Technical Service Bulletin: TSB210188

New Accessory Drive Seal: Lubricating Oil Leaks

Figure 1, Existing Accessory Drive Seal Design.

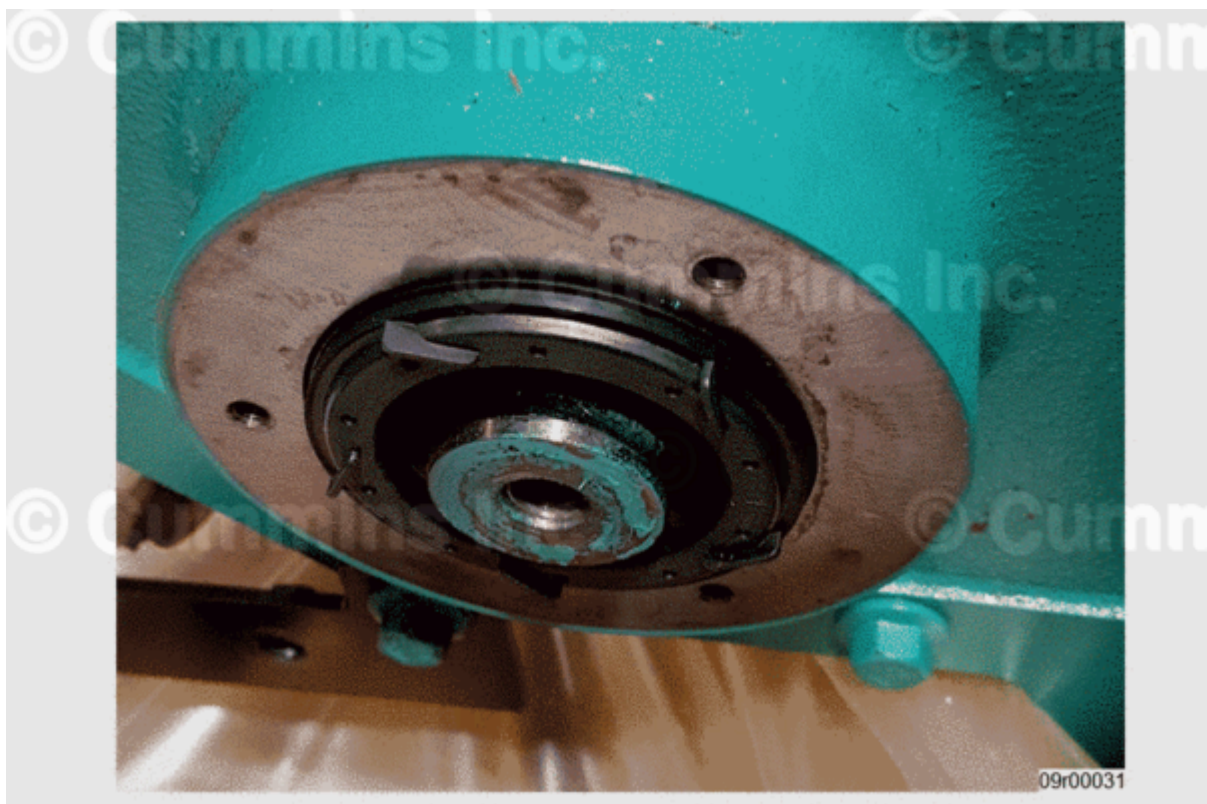
A new accessory drive seal has been released which utilizes a press fit in to the gear cover rather than a three-bolt design.

There has been reports of lubricating oil leaks from the accessory drive seals.

- The existing design can be identified by the three capscrew fitment as shown in Figure 1 below.
- The new design can be identified by the press fitment as shown in Figure 2 below.

- The new accessory drive seal utilizes a press fit design. A new seal installation tool kit **must** be purchased. See Table 1 below for part numbers.
- If an accessory drive seal is being replaced and changing from the three-bolt design to the press fit design, a new pulley **must** also be purchased. The existing pulleys have an extra step in the casting which damages the new accessory drive seal during installation.

Existing pulleys fitted to engines are **not** compatible with new design accessory drive seal. If a new accessory drive seal is purchased a new pulley **must** also be purchased.
